Albuquerque Bernalillo County
Water Utility Authority

Development Review Board (DRB)
Review Comments
Utility Development Section
Reviewer: Kristopher Cadena, P.E.
Phone: 505.289.3301

DRB Project No:	Date:	Item No:
PR-2019-002651	6/29/22	#11
Zone Atlas Page: M-15	**Legal Description: Lot(s)** PARCEL 2A, SUNPORT PARK **Location:** 1501 AIRCRAFT AV SE between I-25 and UNIVERSITY BLVD	
Request For: **SD-2022-00094 – PRELIMINARY/FINAL PLAT**

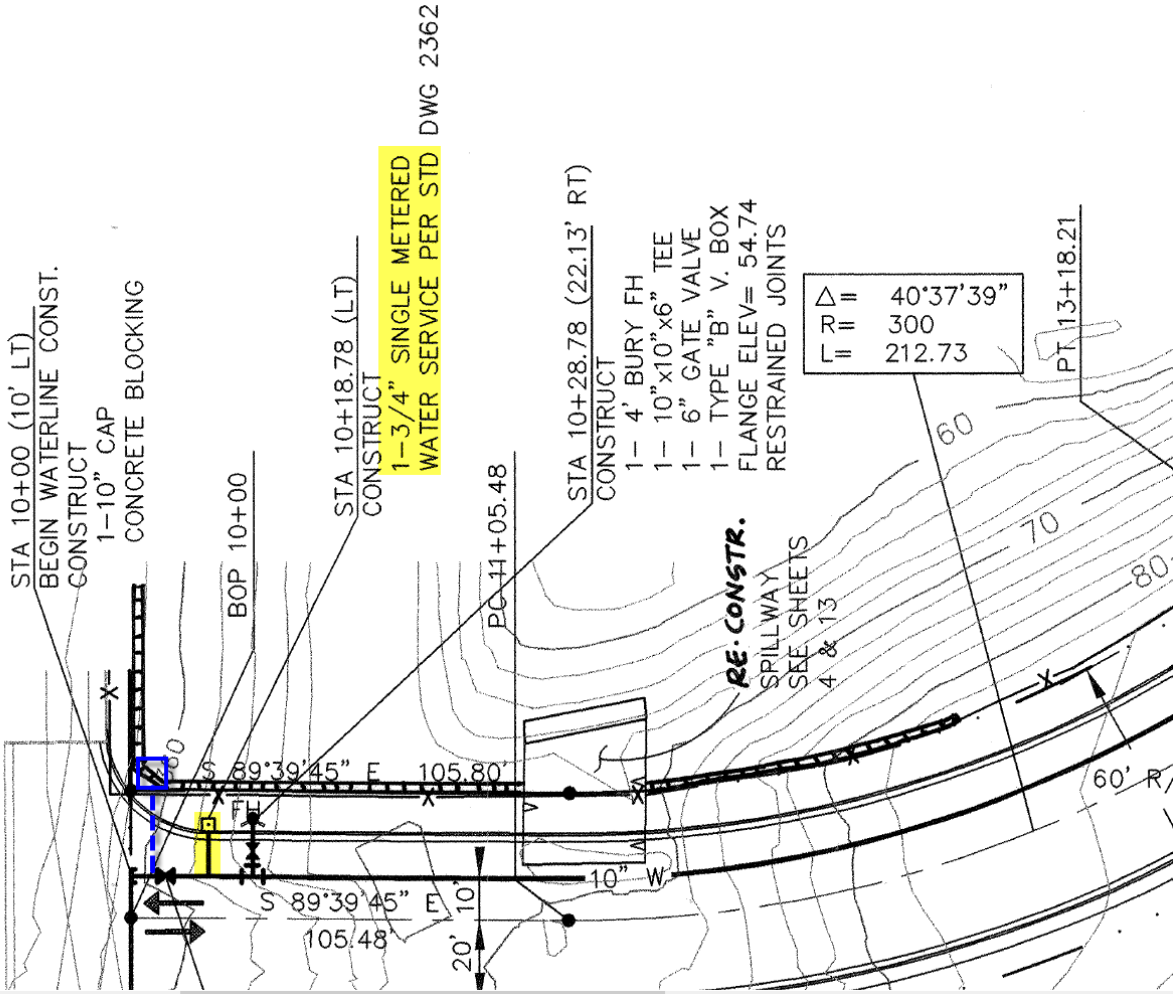
d. The plat proposes a 20' private waterline and gasline easement for the benefit of proposed Parcel 2A2.
        i. Please provide additional dimensioning further south so it is clear near the southeast corner of the platted area.
        ii. This seems to attempt to access the existing public waterline along Aircraft Ave. The image below is an excerpt from the as-builts associated with this existing waterline.

The proposed water service (shown in blue) for proposed Parcel 2A2 shall be perpendicular to the existing waterline and the meter shall be located within the public right-of-way. With that being said, there may be the need for a small private service easement near the southwest corner of existing Lot K (City owned property) to accommodate this service. This additional easement needs to be secured prior to plat approval to ensure the subject property is not landlocked for water service. Based on the as-builts, the existing waterline terminates at or near the eastern property line of proposed Parcel 2A1, therefore requiring the need for this offsite easement. The end of the waterline appears to be 10' west of the existing valve shown in the image below.
